COMMENT (9)
PUBLICATION DATE:
4/4/2019
CITATION # 84 FR 13322

RE: Comments of Natural Resources Defense Council, Friends of the Earth, and Miami Waterkeeper on the Draft Supplemental Environmental Impact Statement for Turkey Point Nuclear Generating Units Nos. 3 and 4 (NUREG–1437, Supplement 5, Second Renewal, draft) (Docket ID NRC-2018-0101).

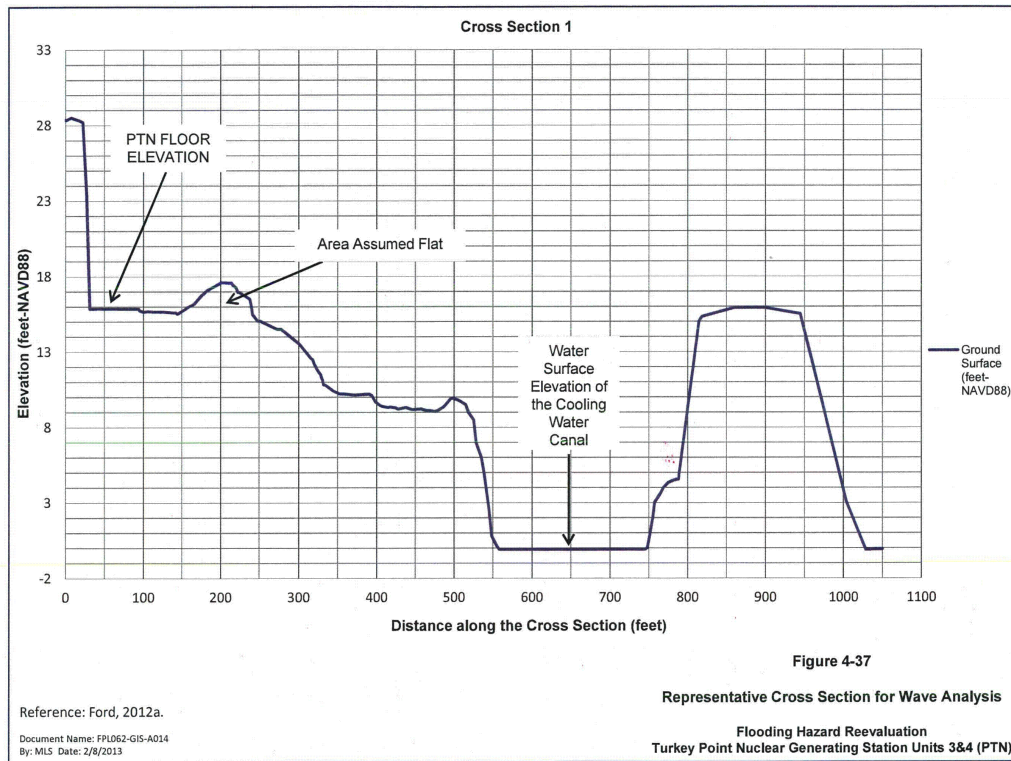
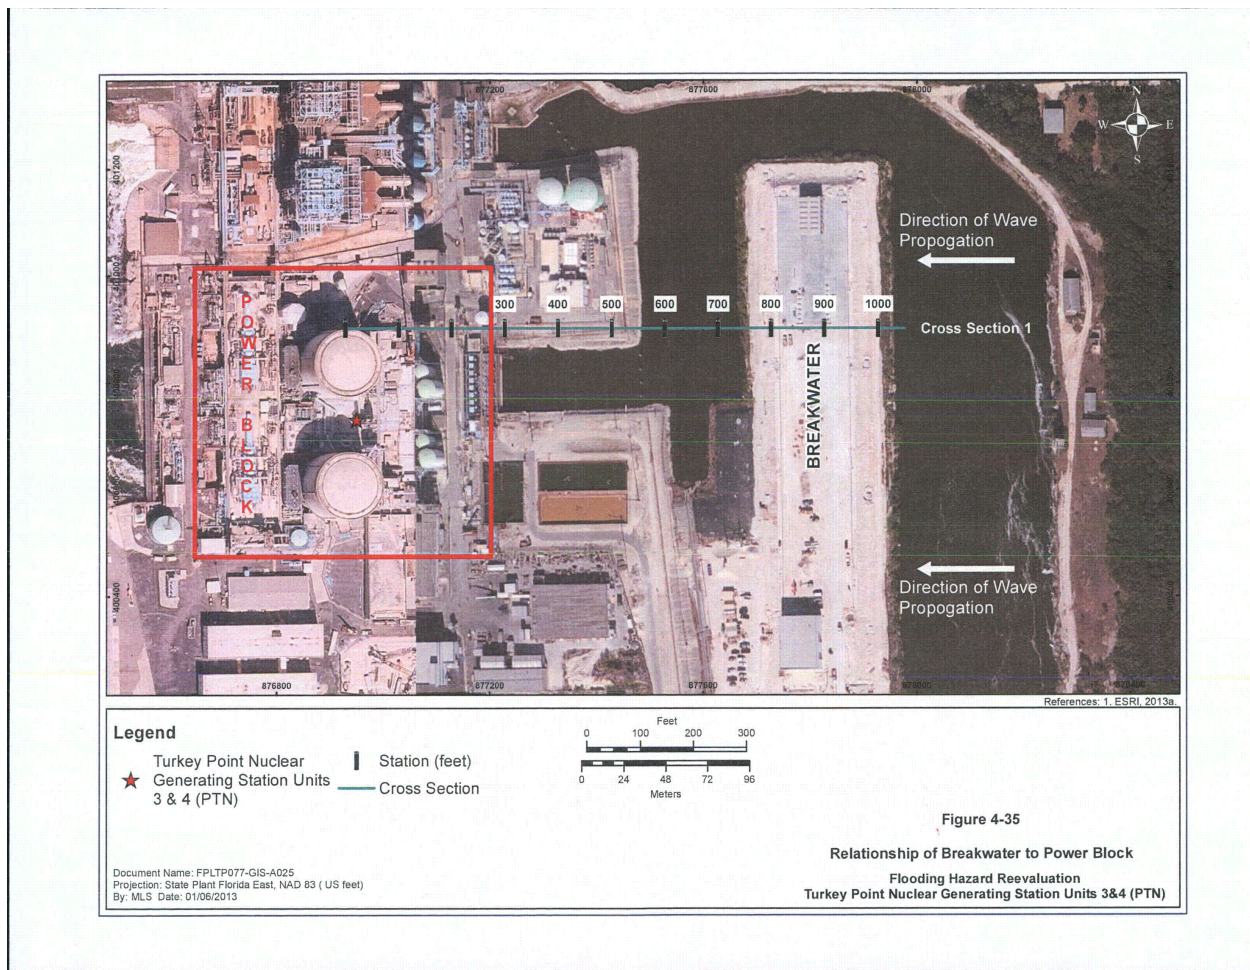
FPL's own studies demonstrate surface water discharges from the cooling canal system are foreseeable. Figure 4-37 below is a representative cross section of the Turkey Point plant.²⁹ Below that (Figure 4-35) is a bird's-eye view of the cross section. FPL's consultant prepared these figures in connection with an NRC-mandated "Flooding Hazard Reevaluation Report" following the Fukushima disaster. The studies show, and NRC Staff confirm, that flood water levels could reach up to 19.1 ft NAVD88³⁰—well above the 16 ft NAVD88 height of the breakwater barrier east of the power block shown in Figure 4-37 that separates Biscayne Bay from the cooling canal.³¹ Notably, this modeling effort only accounted for sea level rise through

the current license period.³² It did not account for additional projected sea level rise and other climate-related flood risks during the subsequent license renewal period.

While the NRC Staff evaluated flooding for safety purposes, it ignored the impacts of flooding on the environment. The impacts of overtopping the cooling canal system are significant. Pollutants in the cooling canals will inundate the Biscayne Bay and the surrounding environment with hyper saline water, tritium, sediment, ammonia, and other pollutants in the cooling canals.
